DOCUMENT 00 90 00
ADDENDUM

ADDENDUM NO. [2] **Date: September 23, 2021**

RE: LA FARGE SCHOOL DISTRICT
ADDITION AND RENOVATION
301 W. ADAMS STREET
LA FARGE, WI 54639
HSR Project 19041-1

FROM: HSR Associates, Inc
100 Milwaukee Street
La Crosse, WI 54603
(608) 784-1830

C101

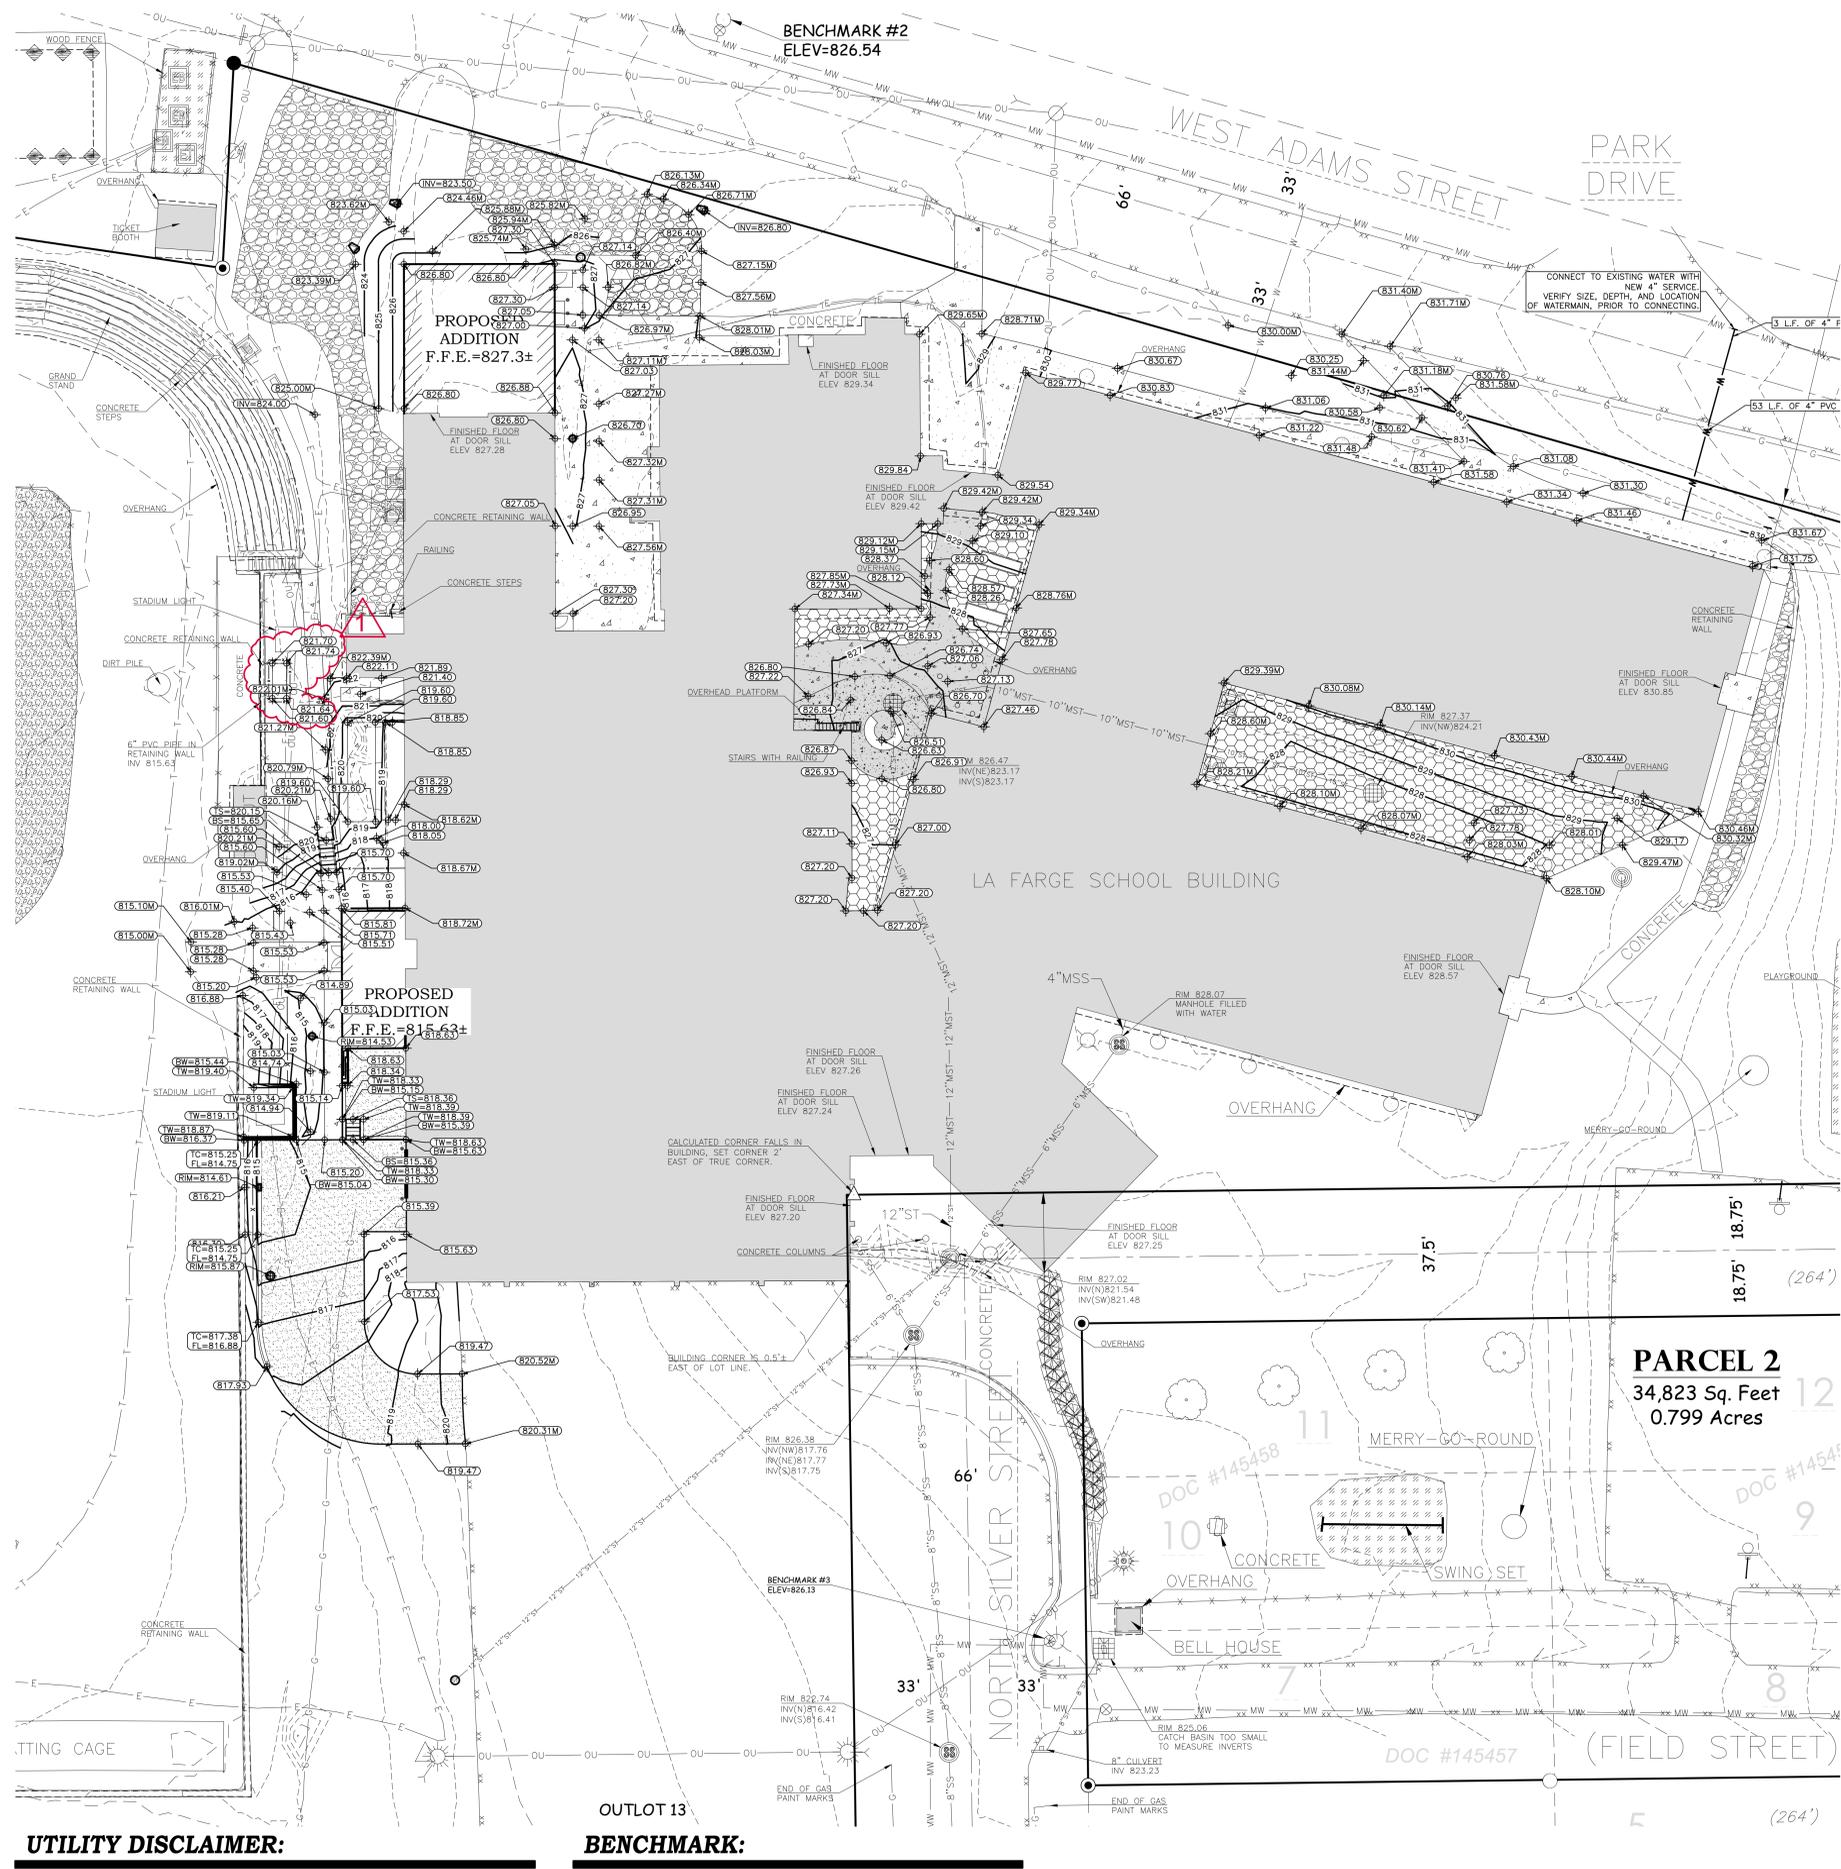
5. Sheet C101 LAYOUT PLAN 30 x 42 attached hereto
 - a. See clouded change
 - b. Added concrete pad for propane tank.
6. Sheet C102 GRADING PLAN 30 x 42 attached hereto

1 ROOF PLAN
1/16" = 1'-0"

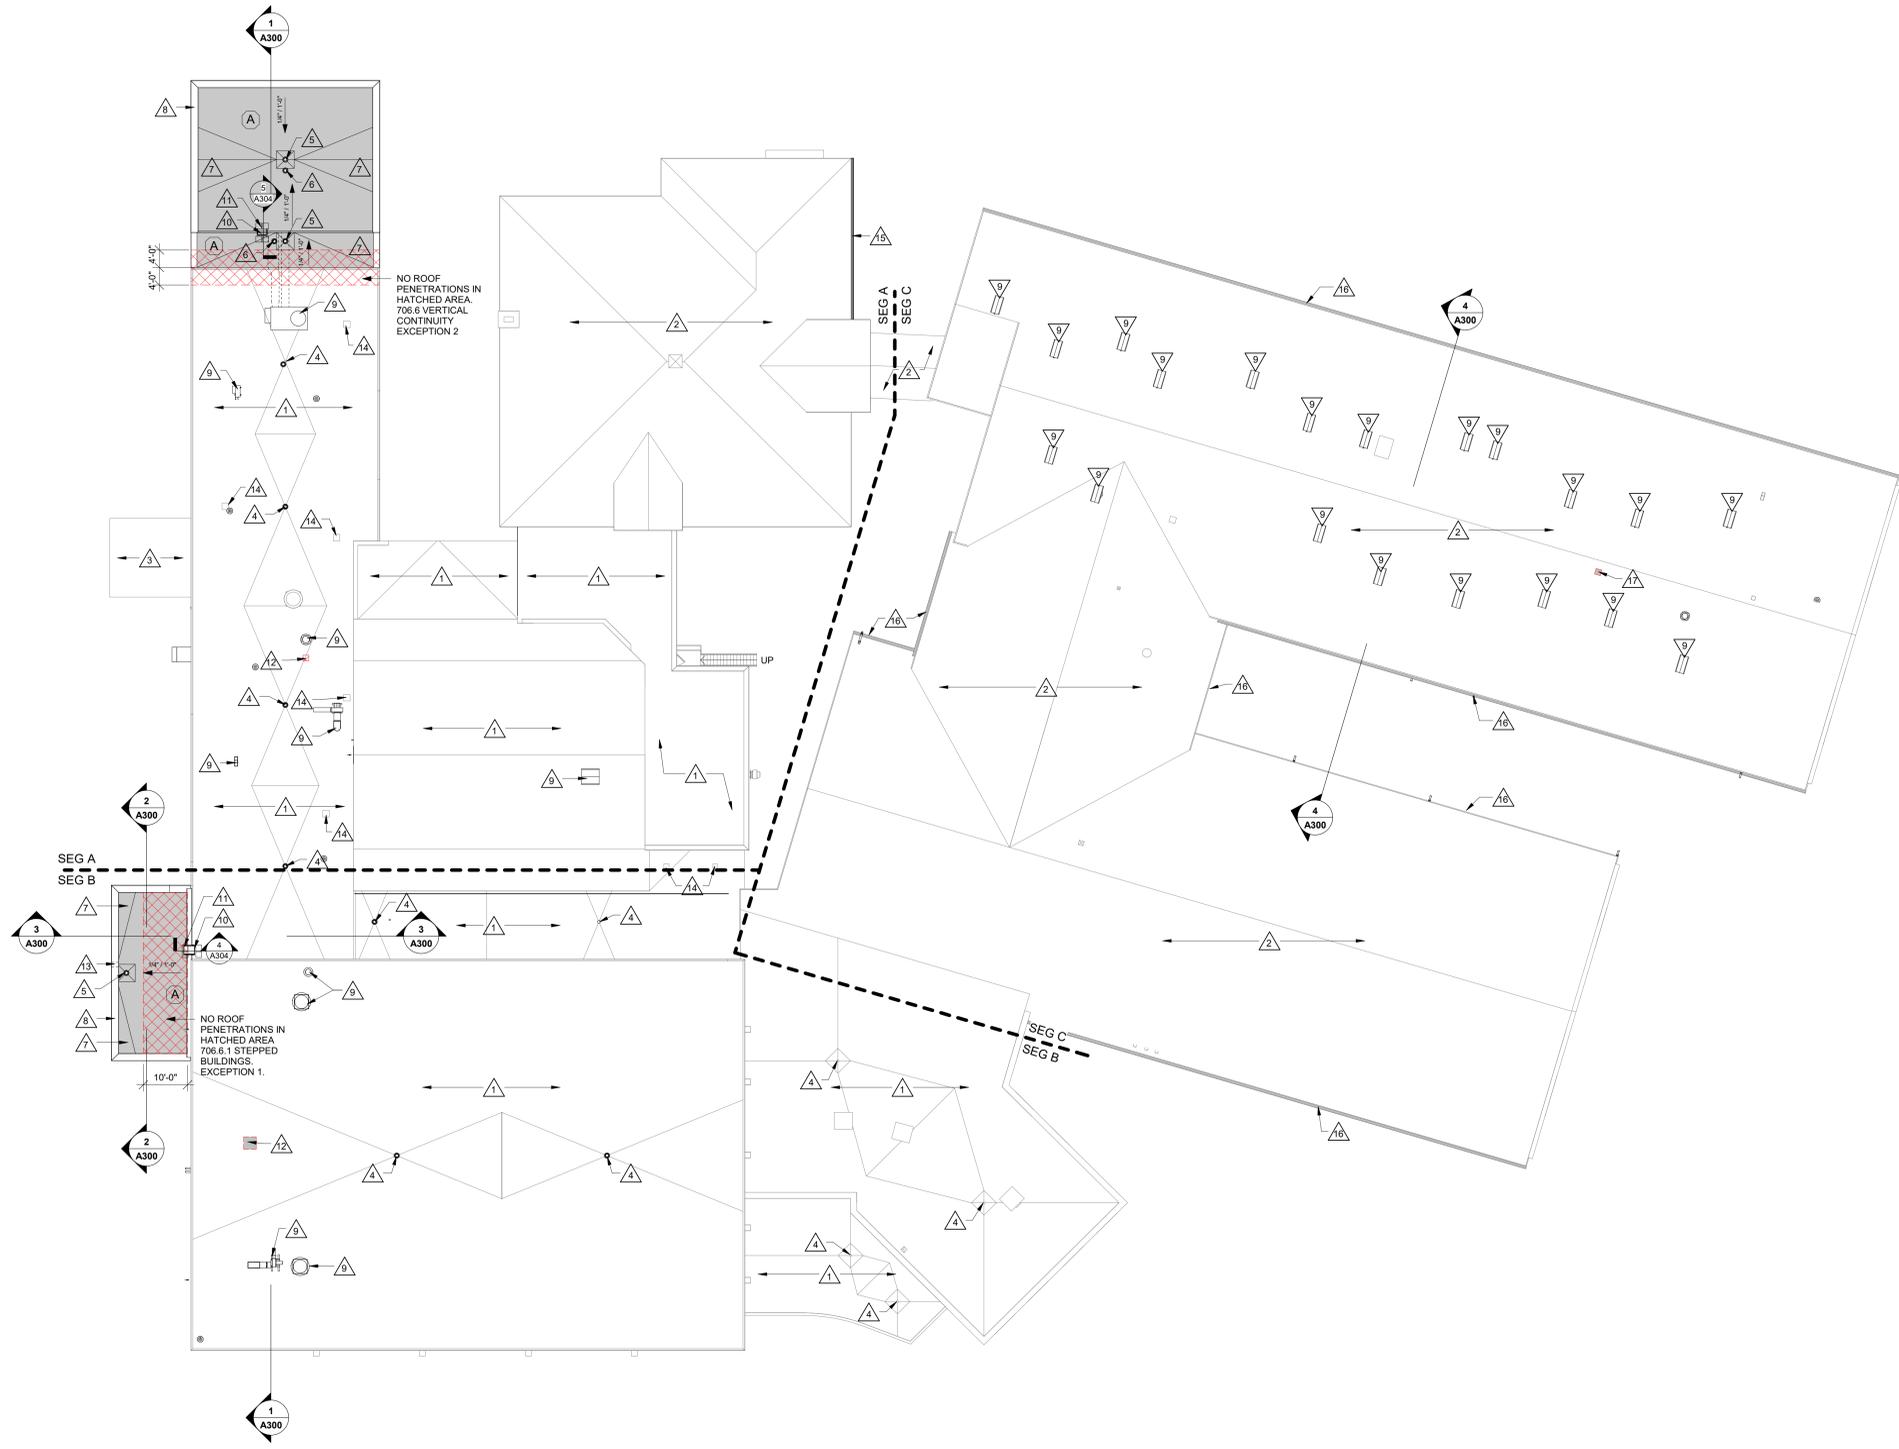
- a. Added concrete pad for propane tank
7. Sheet A120 ROOF 30 x 42 attached hereto
 - a. See clouded change
 - b. Added General Note K to include painting of exposed gas piping at the roof.

ROOF FRAMING PLAN NOTES

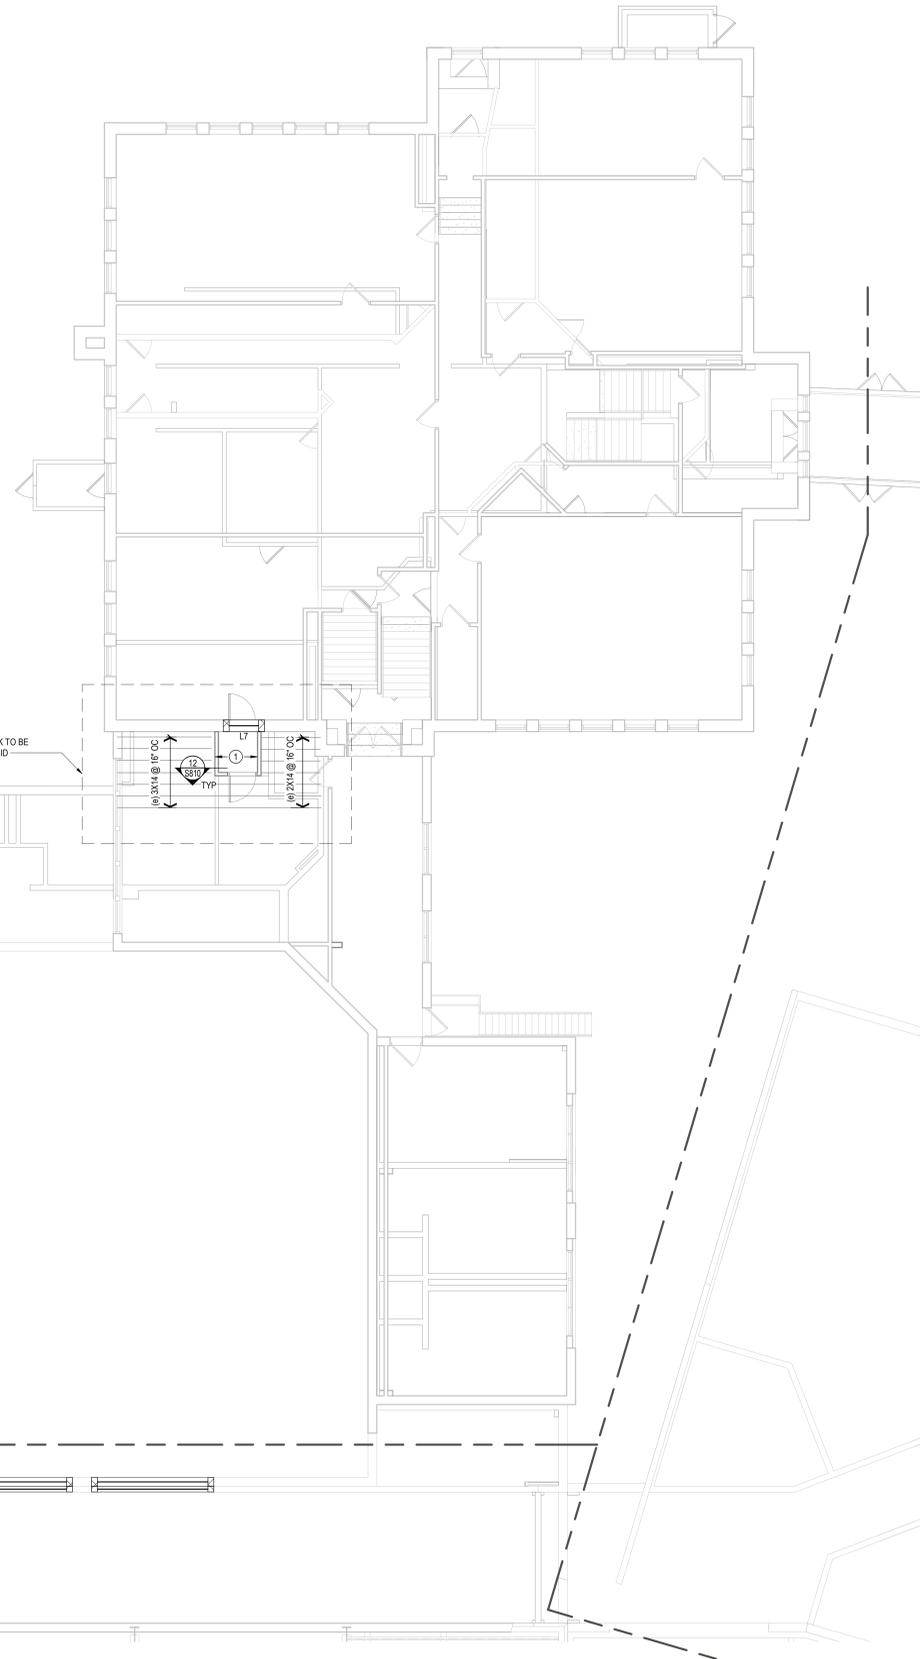
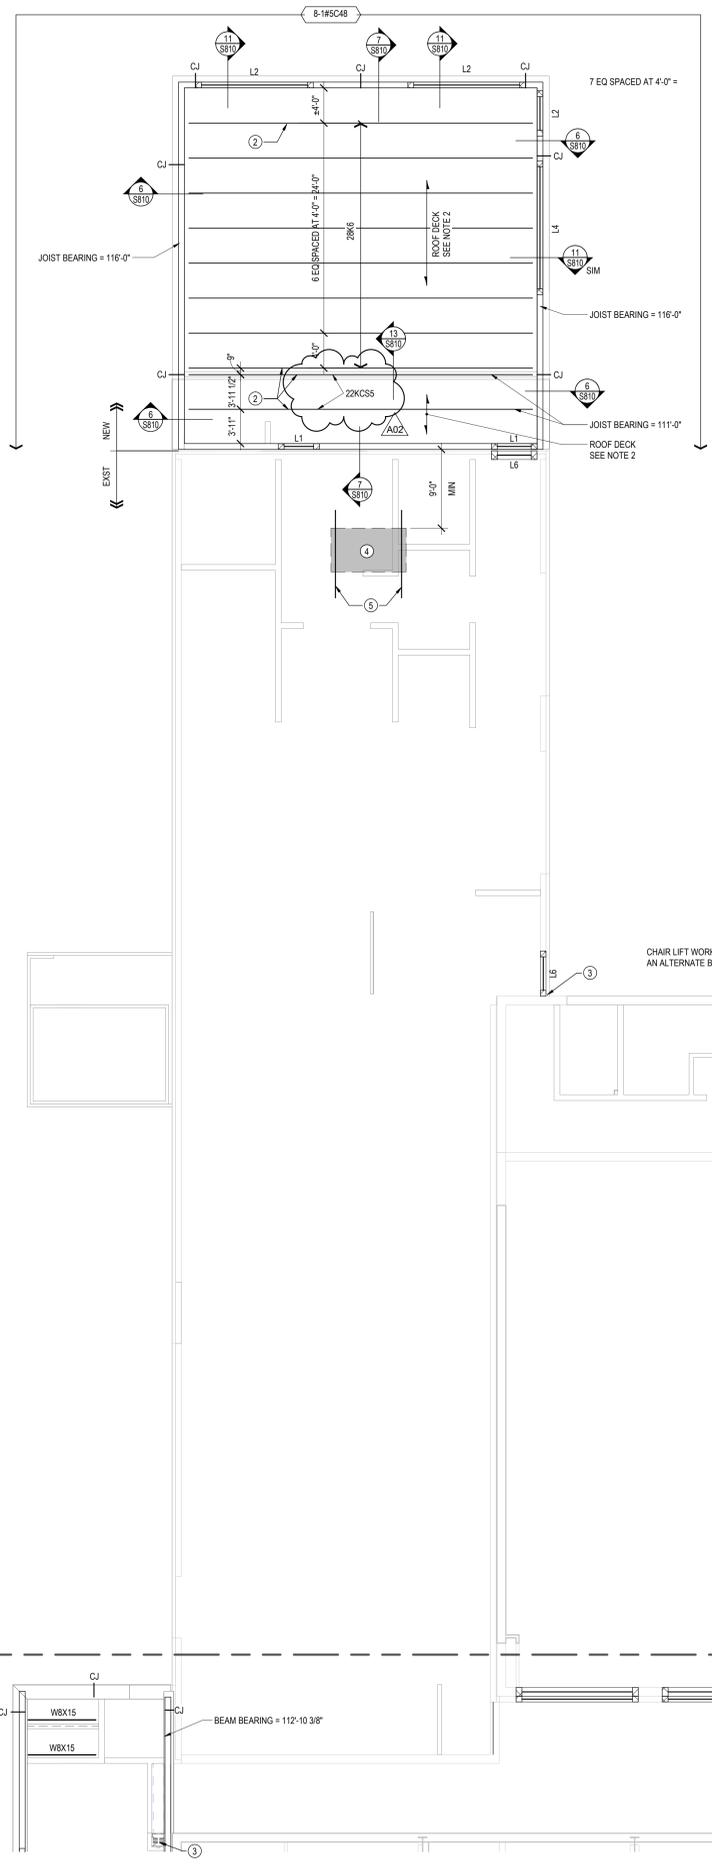
- a. HSR Associates received feedback from some potential bidders that the lead time for steel joists is not compatible with the project schedule presented in the bidding documents. The project schedule will not be changed in this addendum. It is acceptable, at the bidder's option, to substitute structural steel members in place of the steel joists. Any costs associated with the substitution including effects to building services such as plumbing, mechanical and electrical are to be coordinated by the bidder prior to the bid and are to be included in the bid amount. This bidder's option is presented by narrative here and is not presented on the revised drawing.

- b. At bidder's option (see item "a" above) it is acceptable to use W21x50 beams and masonry detail 5/S810 in lieu of 22KCS5 and the associated steel joist details.

- c. At bidder's option (see item "a" above) it is acceptable to use W18X50 beams and masonry detail 5/S810 in lieu of 28K6 and the associated steel joist details.
